The Arcade and 18-20 Corporation Street and 17 Foundry Street, Dewsbury

Summary of Amendments

Doc No. 1705-BDP-AD-XX-RG-Z-00005
Revision: P01
Date: 18 June 2026

PROJECT TITLE: Dewsbury Arcade
BDP JOB NUMBER: P3001705
DRAWING TITLE: Section BB
SCALE: As indicated @ A1
DATE FIRST ISSUED: 21/04/23
DRAWING No: 1705-BDP-AD-XX-SE-A-20002-
REVISION: T02

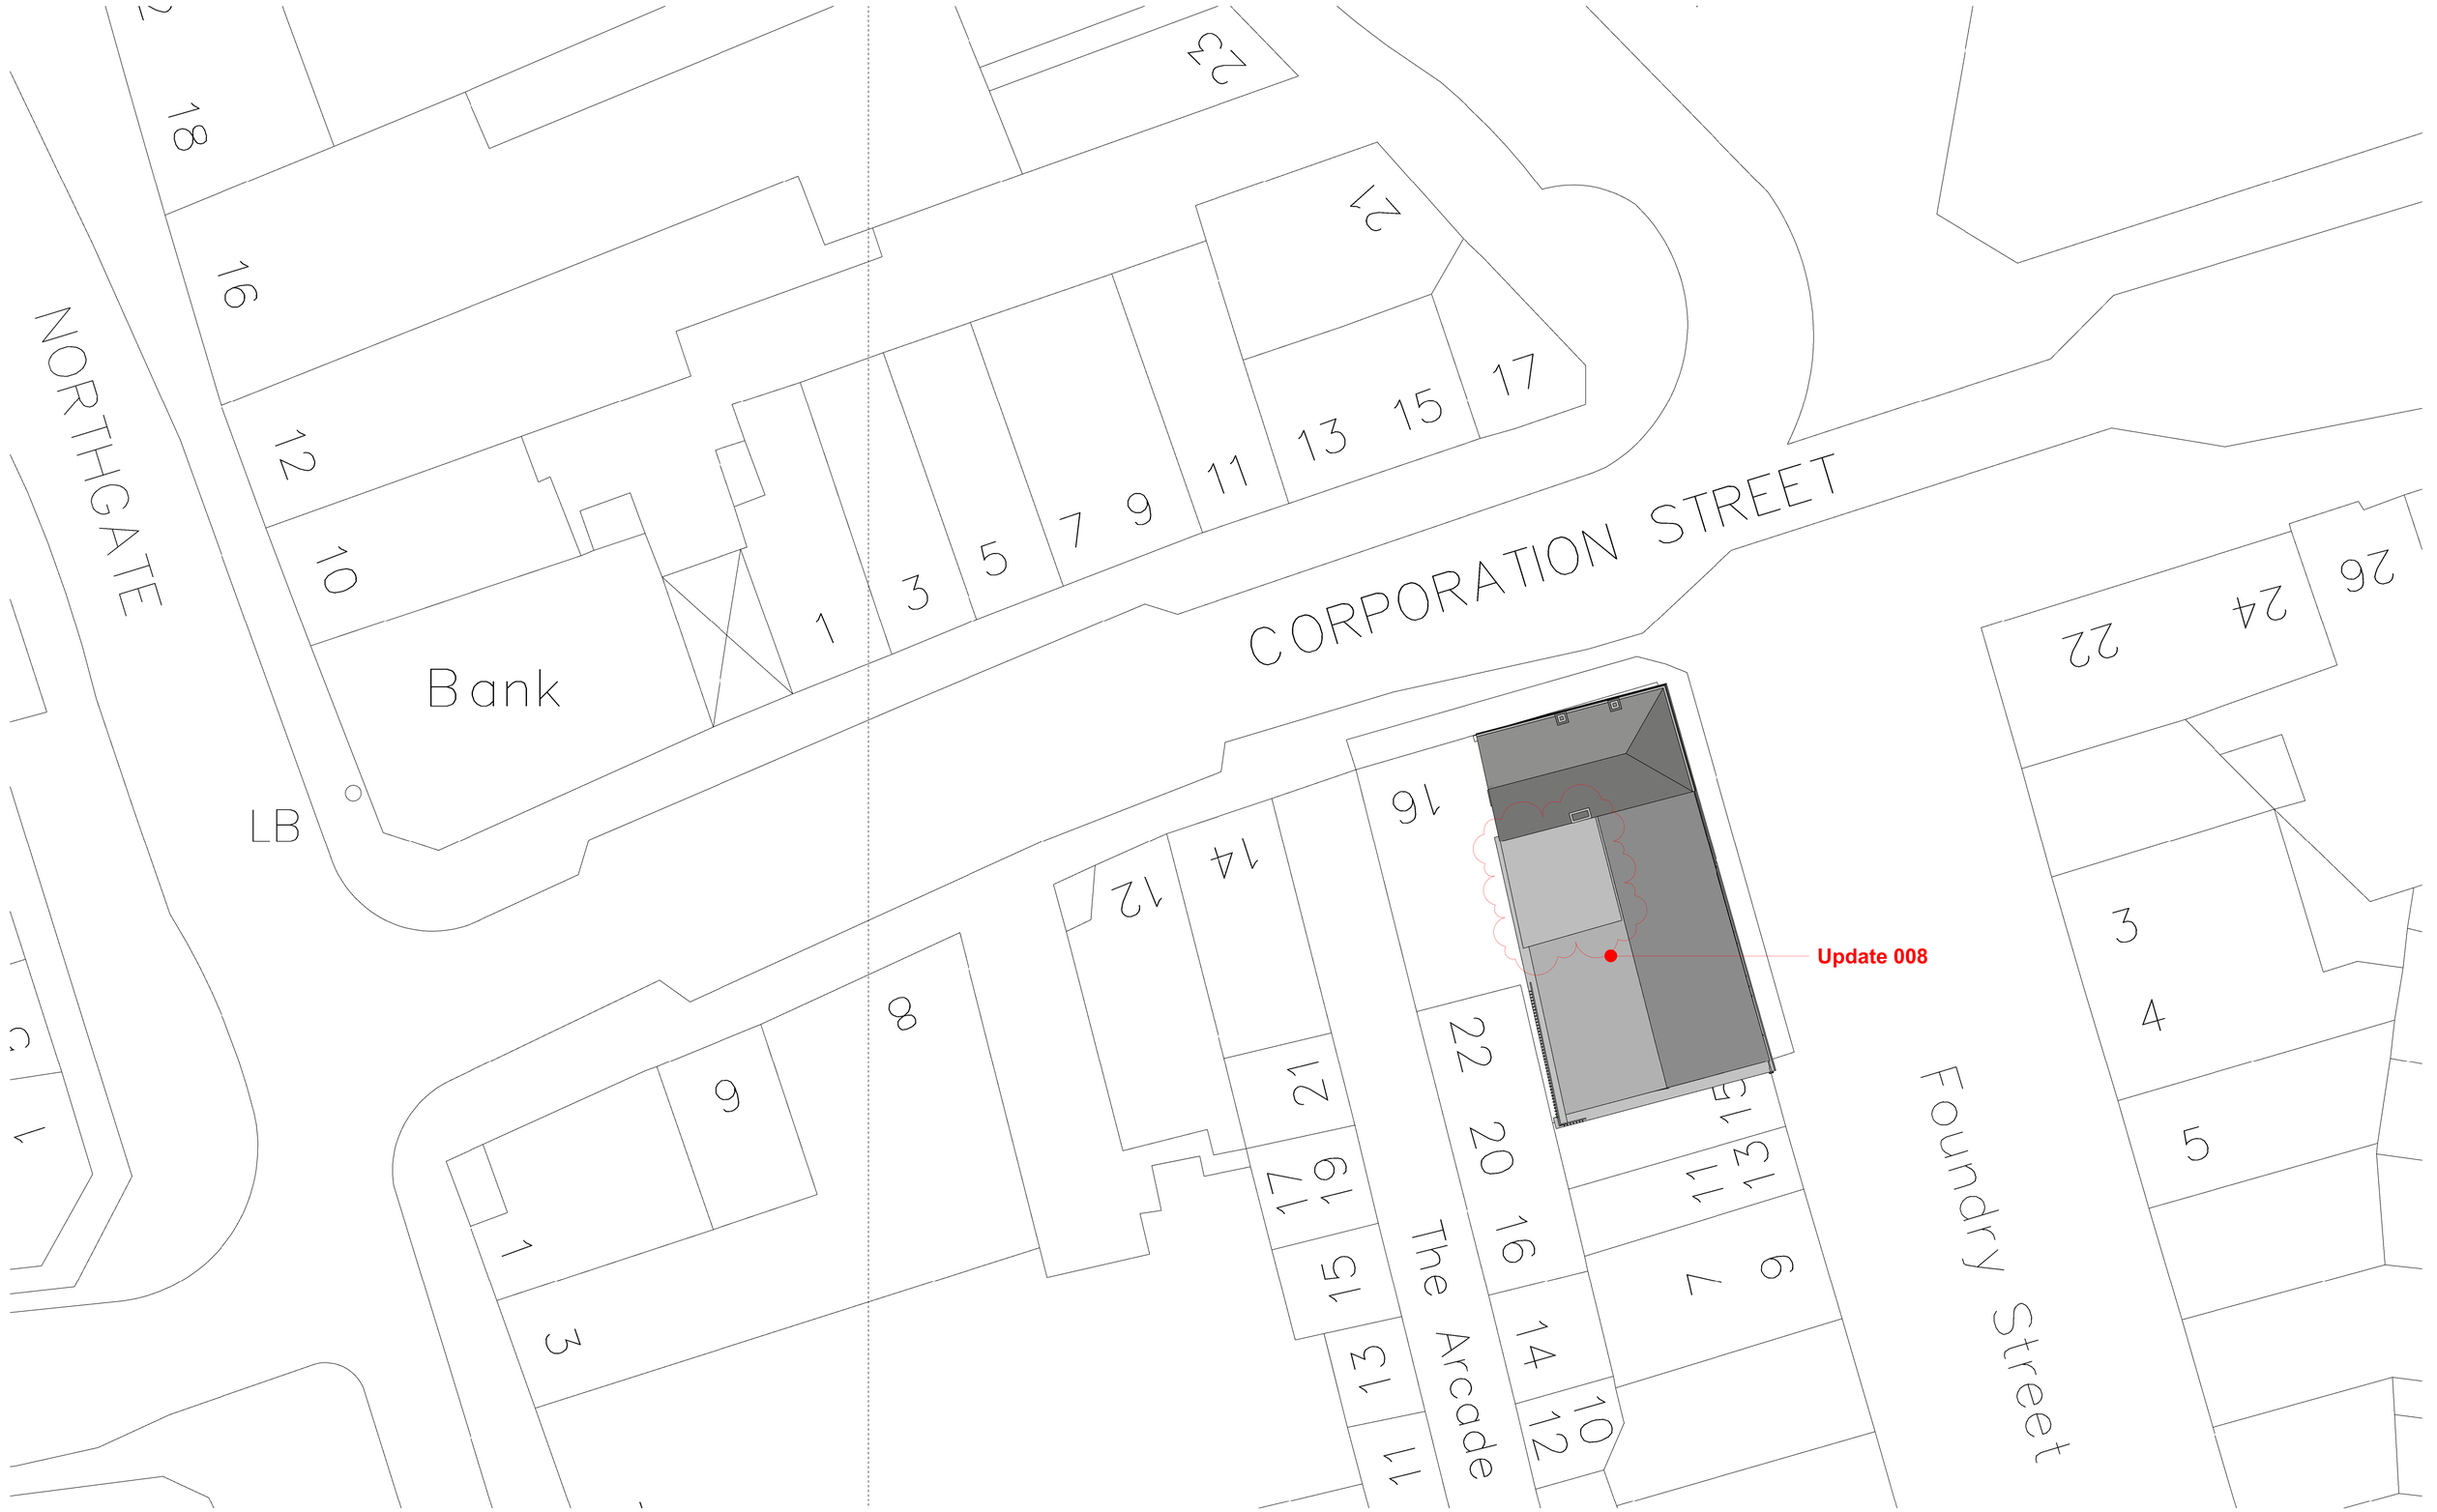
021	**23-25 Market Place** Rear elevation of Market Place building	Gutter and rainwater pipe	Replace the existing cast iron gutter and rainwater pipe in the same size, profile and material.	Rainwater falling on the rear pitch of the Market Place roof falls into valley gutters and the eaves gutter, then into a single rainwater pipe which discharges into the glazed roof gutter, which transports rainwater back towards Corporation Street, into another rainwater pipe, onto the top of a slate roof, into another gutter, into an outlet, and then into an internal rainwater pipe.	This route is extremely convoluted, and has multiple junctions. There is evidence of past leaks in some areas below. A single rainwater pipe for this large area of roof provides no secondary resilience. It also seems unlikely that this was the original route for rainwater discharge.	Remove the existing single rainwater pipe, provide new cast iron rainwater pipes (to match existing profile) at both ends of this gutter discharging directly to the flat roof drainage.	1705-BDP-AD-XX-SE-A-20002_P01	1705-BDP-AD-XX-SE-A-20002_T02

022	**Central Arcade, 14-16 Corporation Street and 18-20 Corporation Street** Refer to elevation drawings	Windows	Repair windows where possible using traditional techniques. Some windows were known to have extensive wet or dry rot, or were absent and were therefore proposed to be replaced.	Additional windows were found to have extensive wet and dry rot. (2 to 14-16 Corporation Street North Elevation, 2 to Central Arcade East Elevation, and 2 to Central Arcade West Elevation, 3 to 18-20 Corporation Street North Elevation)	These additional windows are so extensively decayed that they are unsuitable for repair.	Replace 6 no. windows, in addition to the 3 no. already proposed to be replaced (in unit 30, shown on Section AA). Replacement windows to match existing in size, proportions and timber profiles.	1705-BDP-AD-XX-EL-A-20001_P01 1705-BDP-AD-XX-EL-A-20005_T01 1705-BDP-AD-XX-EL-A-20004_P01 1705-BDP-AD-XX-SE-A-20002_P01 1705-BDP-18-ZZ-EL-A-00002_P04	1705-BDP-AD-XX-EL-A-20001_T02 1705-BDP-AD-XX-EL-A-20003_T02 1705-BDP-AD-XX-EL-A-20004_T02 1705-BDP-AD-XX-SE-A-20002_T02 1705-BDP-18-ZZ-EL-A-00002_P05

PROJECT TITLE: Dewsbury Arcade
BDP JOB NUMBER: P3001705
DRAWING TITLE: Plans as Proposed
SCALE: As indicated @ A1
DATE FIRST ISSUED: 15/11/21
DRAWING NO: 1705-BDP-18-ZZ-PL-A-00002-
REVISION: P07

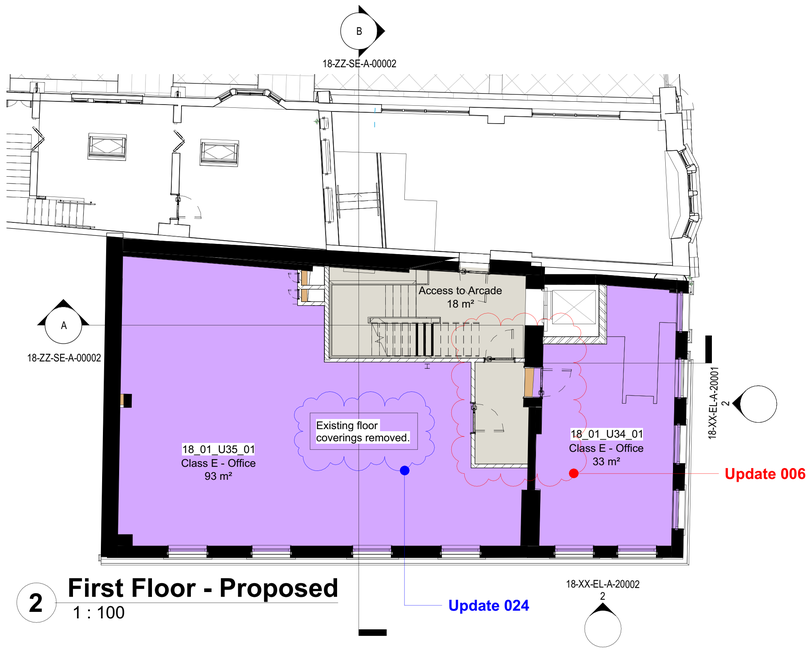
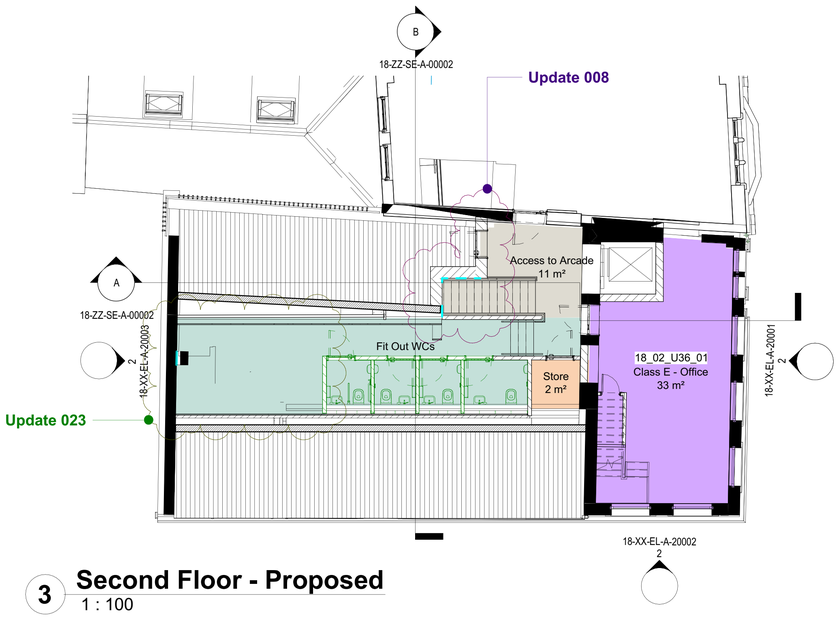
028	**18-20 Corporation Street and 17 Foundry Street** Units 32-36	Ceilings and walls	Repair damaged ceilings and walls.	The ceilings and wall finishes were found to be in a poorer state than expected, incorporating modern materials and with extensive damp.	Where present, plaster had debonded from the laths and masonry and therefore was not suitable for patch repair. There is also a need to treat dry rot in the masonry, requiring plaster to be removed.	Remove damaged ceiling finishes and replace with plasterboard finishes. Remove damaged wall finishes and replace with lime plaster. This approach has already had consent elsewhere in the arcade buildings.	1705-BDP-18-ZZ-PL-A-00002_P06	1705-BDP-18-ZZ-PL-A-00002_P07
029	**17 Foundry Street** Unit 33	Shopfront	Replace modern shopfront to match appearance of the original shopfront.	A structural column has been in part of the existing shopfront construction.	This column clashes with the proposed splayed door opening.	Minor change to the alignment of the splayed door opening.	1705-BDP-18-ZZ-PL-A-00002_P06	1705-BDP-18-ZZ-PL-A-00002_P07

Finishes to ceilings to be removed and replaced with plasterboard. Finishes to walls to be removed and replaced with lime plaster.

Update 028
